SERVICE CAMPAIGN BULLETIN

CAMPAIGN REF : 010
TITLE : Secondary latch re-work
DOCUMENT # : 11 A 014

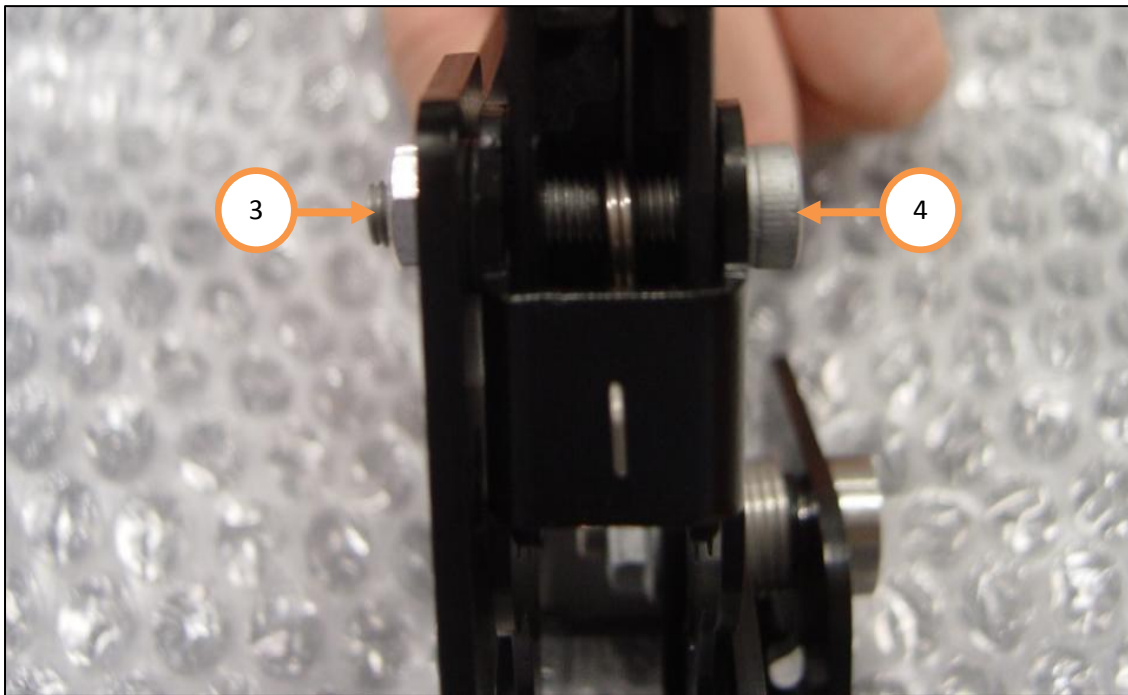
1. Over tightening of fixing (1) will result in the potential of the secondary latch failing. Free play should be present between the igus bush and link arm (2).

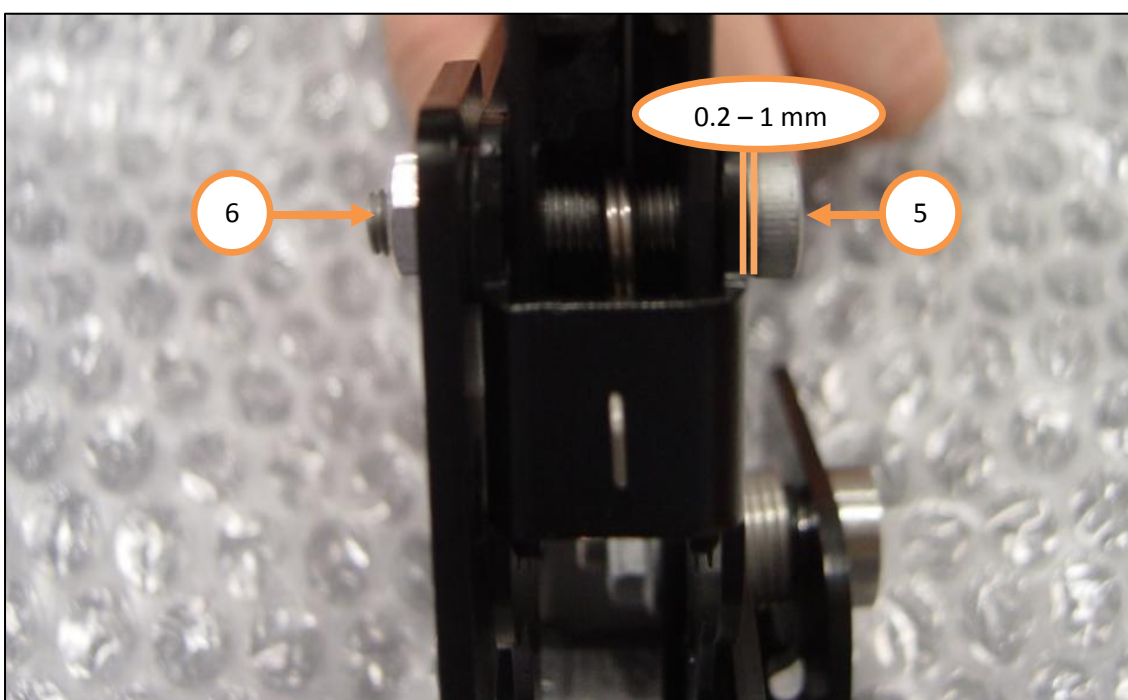
2. Undo nut (3) using a 7mm spanner and remove bolt (4) ensuring suitable grips are used.

3. Re-assemble these components to ensure a correct gap between the fixing head and clamp surface. Re-tighten bolt (5) ensuring a visible gap of 0.2 - 1.0mm is visible between the fixing head and clamp surface. Once the bolt is secured use Loctite 222 to secure nut (6).
